## OMEGA CHEMICAL SITE PRP ORGANIZED GROUP

Re: OPOG Comments on the Significance of the EPA 2012 Groundwater Monitoring Report for 2010 and 2011 (June 2012) on EPA's Remedy Selection for OU2 at the Omega Chemical Superfund Site

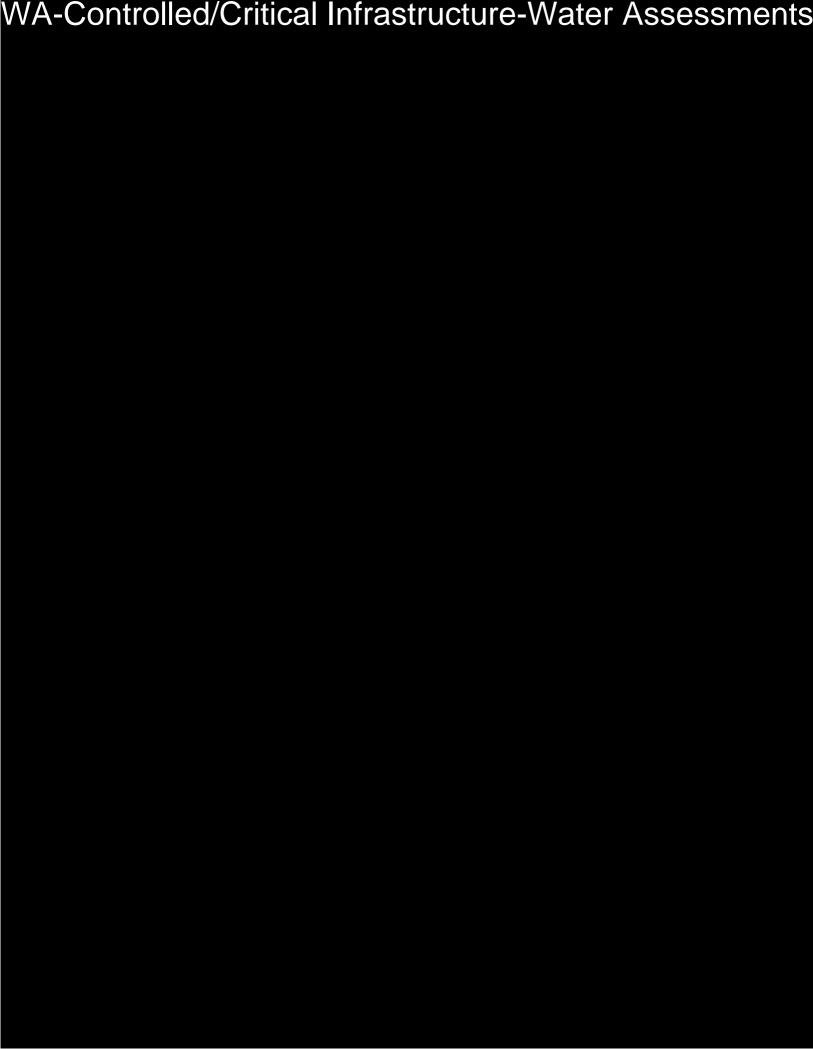
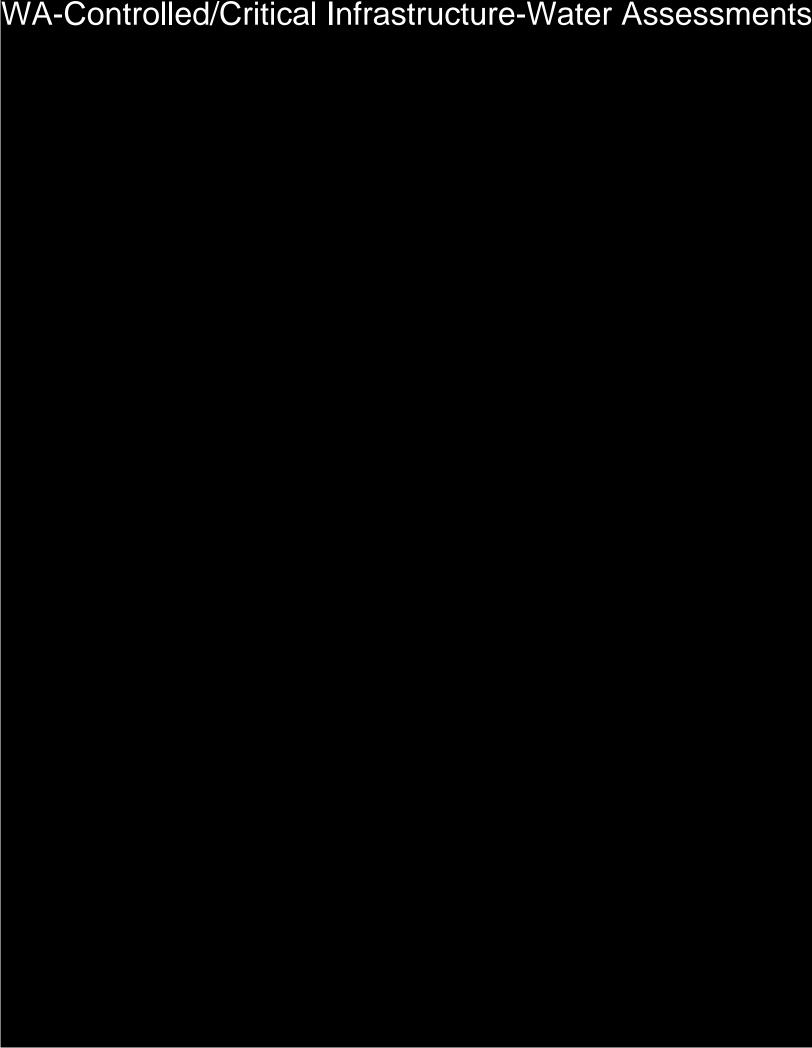
As presented in the attached figures, the lateral extent of contamination for PCE and TCE is retracted when compared with EPA's 2007 Remedial Investigation (RI) plume characterization and EPA's August 2010 RI/FS characterization of the plume. This retracted plume position is supported by EPA's contractor's own interpretation as presented in the June 2012 report. In reaching its 2010 conclusion on Omega's contribution to the OU2 plume, EPA's analysis was highly dependent upon a set of hydropunch data taken from the shallow groundwater zone. As demonstrated by the results from the ongoing EPA groundwater monitoring well tests, these hydropunch data may have been representative of local contaminant sources but not of the migration of mass from the Omega site. Since EPA has not repeated testing from hydropunch locations, EPA cannot determine whether these shallow hydropunch wells remain contaminated with releases from local sources. However, a review of the groundwater monitoring well data from 2007 through 2011 clearly supports the premise that the Omega plume never reached MW-28, MW-29, or MW-30.

not been detected above the 5 ug/l maximum contaminant level since sampling began in 2007. It appears that based on a comparison of the 2007 RI 5 ug/l plume contours, based on hydropunch data, and the 2011 5 ug/l plume contours for PCE based on groundwater monitoring well data, EPA's depiction of the PCE plume has retracted approximately 1,500 feet northward (see attached PCE comparison figure). This retracted distance appears conservative in that the concentrations used to bound the southern plume contour are significantly below 5 ug/l and as such could be placed much closer to the Cenco well MW-710. This interpretation could retract EPA's 2007 PCE 5 ug/l contour by as much at 2,500 feet from the 2007 RI interpretation.

In addition to examining the horizontal extent of the plume in the leading edge, we also examined the vertical distribution of PCE in the leading edge. Comparison of vertical distribution of PCE between 2007 and 2011, specifically along cross section C-C', demonstrate that attenuation of COCs is occurring and that the need for active remediation in the leading edge is not supported by the data collected. The vertical contaminant profile at MW-27 is striking in the degree to which the spatial distribution of PCE above 100 ug/l is reduced substantially. This further supports the use of a MNA remedy in the leading edge along with source control, as necessary, for individual properties in the leading edge that continue to contribute mass to the plume.

TCE plume contours exhibit similar behavior to that of PCE and the resulting 2011 data interpretation is a plume length that is approximately 2,000 feet less than EPA's 2007 RI/FS interpretation. Data trends in the aforementioned three leading edge monitoring wells mimic those of PCE in a downward trend (see TCE comparison figure). As with PCE, the TCE 5 ug/l contour boundary could reasonably be placed closer to the Cenco well identified as MW-710 thereby resulting in a further retraction of an additional 1,500 for a total of 3,000 feet. In fact, a review of the data presented in the June 2012 groundwater monitoring report demonstrate that none of the contaminants of concern for OU2 have expanded and additional COCs have retracted when compared with EPA's RI/FS characterization.
